Attached is Part 3 of 4 of the response to RAI No. 547, Question 03.07.02-78.

The following table indicates the respective pages in the response document, "RAI 547 Supplement 6 Response US EPR DC.pdf," that contain AREVA NP's response to the subject question. Appended to this file are affected pages of the U.S. EPR Final Safety Analysis Report in redline-strikeout format which support the response to RAI 547, Question 03.07.02-78.

Subject: Response to U.S. EPR Design Certification Application RAI No. 547 (6499, 6359), FSAR Ch. 3 - NEW PHASE 4 RAI, Supplement 6 - Part 3 of 4
Sent Date: 4/29/2013 5:24:28 PM
Received Date: 4/29/2013 5:25:35 PM
From: WILLIFORD Dennis (AREVA)

Figure 3.7.2-152—Foundation Basemat Model with Solid Element Basemat

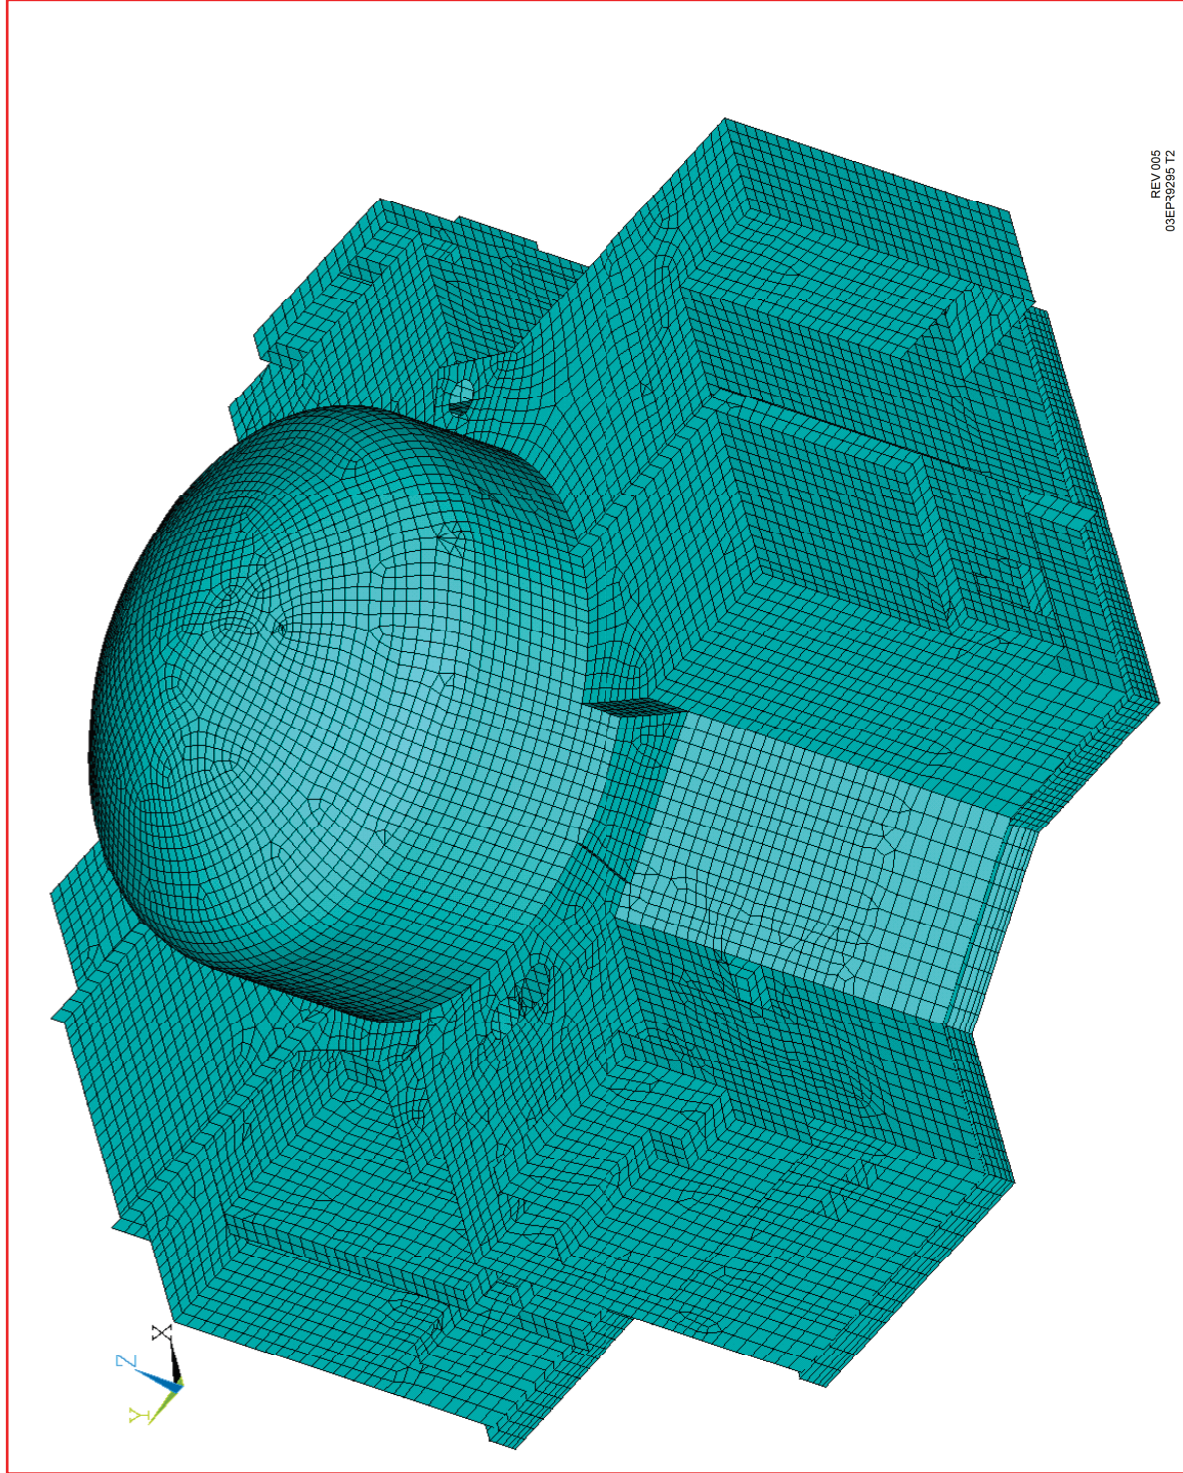
~~The details of the seismic design loads for the NI Common Basemat are obtained using the 3D FEM for NI Common Basemat Foundation Models (dynamic and static) including the types of finite elements used are described in Section 3.7.2.3.1.4. The NI Common Basemat Structure foundation basemat is analyzed and designed using the ANSYS V10.0 SP1 finite element overall computer model (a static model) for NI Common Basemat Structure Seismic Category I structures, which is described in Sections 3.8.1.4.1 and 3.8.5.3. The NI Common Basemat Structure Foundation Model includes the RCB, RB internal structures, RSB, FB, and SBs, as well as the NI Common Basemat Structure foundation basemat and subgrade.~~

~~Figure 3.7.2-151—Solid Element Basemat shows the basemat portion of the full model, and Figure 3.7.2-152—Foundation Basemat Model with Solid Element Basemat shows the full model, including the NI superstructure. ANSYS SOLID45 solid elements are used to model the concrete basemat foundation in the NI Common Basemat Structure static analysis. SOLID45 is a three-dimensional, eight-node element that is suitable for moderately thick structures. Depending on the thickness of the basemat, between three to five layers of SOLID45 elements are used in the model, with an average of four elements in the typical 10 feet thick basemat areas. Figure 3.8-103—Deleted Nuclear Island Common Basemat Structure Foundation Basemat ANSYS Model illustrates the model used for design of the basemat.—~~
